UNITED STATES PATENT AND TRADEMARK OFFICE

APPLICATION NO.	FILING DATE	FIRST NAMED INVENTOR	ATTORNEY DOCKET NO.	CONFIRMATION NO.
10/026,477	12/27/2001	Hong Suk Yoo	8733.561.00	7762
30827	7590	01/16/2004	EXAMINER	
MCKENNA LONG & ALDRIDGE LLP			RUDE, TIMOTHY L	
1900 K STREET, NW			ART UNIT	
WASHINGTON, DC 20006			PAPER NUMBER

Office Action Summary	Application No. 10/026,477	Applicant(s) YOO ET AL.	
	Examiner Timothy L Rude	Art Unit 2871	<i>NW</i>

DETAILED ACTION

FIG.8D

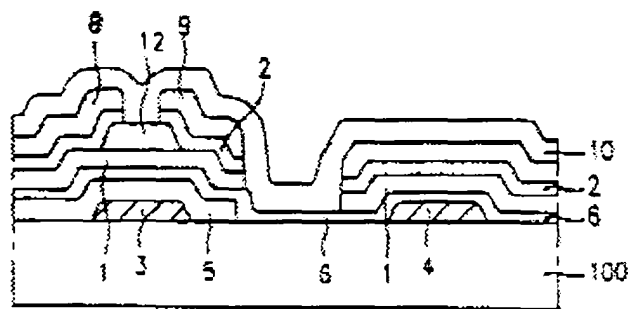
As to claim 1, Moon discloses in the 5th embodiment (col. 6, lines 8-63 and Figures 8A-8D) a liquid crystal display (LCD) device comprising:

- a first substrate defined by first and second regions;
- a storage capacitor electrode, 4, and a gate electrode, 3, respectively formed in the first and second regions of the first substrate;
- a gate insulating layer, 5 and 6, formed on an entire surface of the first substrate so that the first region (on the right of Figure 8D) is thinner than the second region (on the left of Figure 8D);
- a semiconductor layer, 1, and source, 8, and drain, 9, electrodes deposited on the gate insulating layer of the second region;

a conductive layer (unlabeled layer between layers 2 and 10 above 4) formed on the gate insulating layer of the first region;

a pixel electrode (not shown, inherent to comprise functional device) electrically connected to the drain electrode and the conductive layer;

As to claim 2, Moon discloses in Figure 8D the LCD device as claimed in claim 1, wherein the gate insulating layer of the first region is a single-layered film, 6, and the gate insulating layer of the second region is a double-layered film, 5 and 6.

As to claim 4, Moon discloses in Figure 8D the LCD device as claimed in claim 1, wherein the first region is a storage capacitor region, and the second region is a thin film transistor region (col. 6, lines 10-16).

As to claim 15, Moon teaches in Figure 8D a liquid crystal display (LCD) device comprising:

- a first substrate; a second substrate;
- a liquid crystal layer formed between the first and second substrates;
- a storage capacitor, (combination of 4, 6, 1, 2, and unlabeled 9; col. 6, lines 10-30), formed in a first region of the first substrate;
- a thin film transistor formed in a second region of the first substrate.
- a gate electrode, 3, for the thin film transistor and a storage capacitor electrode, 4, spaced apart from the gate electrode, both formed on the first substrate;
- a first insulating layer, 5, formed on the surface of the first substrate except an upper portion of the storage capacitor electrode;
- a second insulating layer, 6, formed on the first insulating layer and the storage capacitor electrode.

As to claim 17, Moon discloses in Figure 8D the liquid crystal display device as claimed in claim 15, further comprising a semiconductor layer, 1, formed above the second insulating layer in the second region and used as a channel of the thin film transistor.

As to claim 18, Moon discloses in Figure 8D the liquid crystal display device as claimed in claim 15, further comprising a source electrode, 8, and a drain electrode, 9, opposing each other and formed above the semiconductor layer.

As to claim 19, Moon discloses in Figure 8D the liquid crystal display device as claimed in claim 15, further comprising a conductive layer (unlabeled 9 between 2 and 10) of the same material as the source and drain electrodes and formed on the second insulating layer in the first region.

As to claim 20, Moon discloses in Figure 8D the liquid crystal display device as claimed in claim 15, further comprising an ohmic contact layer, 2, formed at an interface between the source and drain electrodes and the semiconductor layer.

As to claim 21, Moon discloses in Figure 8D the liquid crystal display device as claimed in claim 15, further comprising a passivation layer, 10, having a contact hole and formed on an entire surface including the conductive layer and the source and drain electrodes to expose upper portions of the drain electrode and the conductive layer.

As to claim 26, Moon discloses in Figure 8D the liquid crystal display device of claim 15, wherein the first insulating layer, 5, and the second insulating layer, 6, are deposited on the second region where the thin film transistor is formed, and only the second insulating layer, 6, is formed on the first region where the storage capacitor is formed.
